Access Compliance Report

Public Rights-of-Way

Intersection ID: 2549	Main Street: BEARDSLEY_DR	Cross Street: MCCHESENEY_DR	Location:	N
ADA ID: B96319890575	Ramp Type: PerpDiag	Initial Pass/Fail: Pass	Overall Compliance: No	Severity Score: 5.25
Codes/Mitigation Info/Possible Solution		Field Measurements/Component Compliance

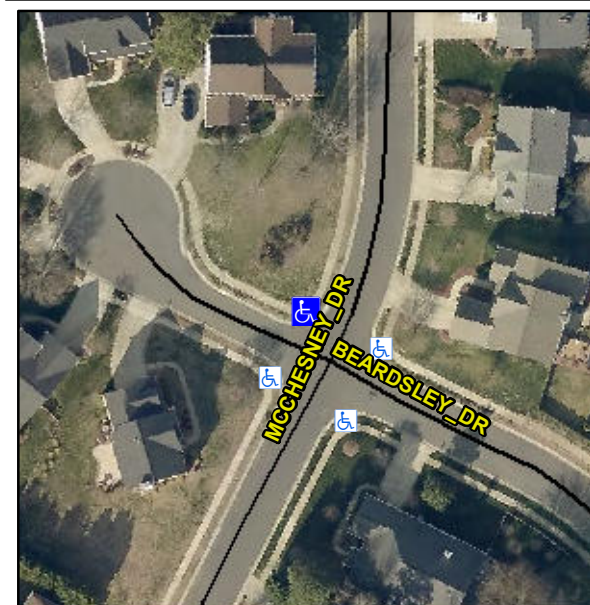
Remove & Replace Curb Ramp With Two New Directional Ramps or Equivalent. Remove & Replace Gutter.

R304.5.3, R304.2.2-Perp, R304.3.2-Para, R304.2.3, R305.2
